star bulletin

Date: June
Order No.: P-B-82.10/704
Group: 82

**SUBJECT: Model 204, Model Years 2008 - 2011
Check Right and Left Tail Lamp Bulb Carrier, Replace if Necessary**

Object number and index

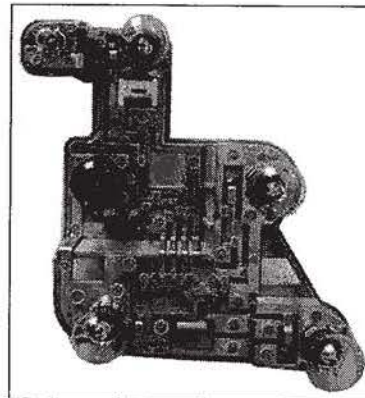
The object number and index on each bulb carrier will be verified and the carrier(s) will be replaced if necessary. Both tail lamp connectors and wire contacts will be inspected for evidence of oxidation and the connector(s) and affected wire contact(s) will be replaced if necessary. Customers who previously paid for this repair can request reimbursement with appropriate documentation.
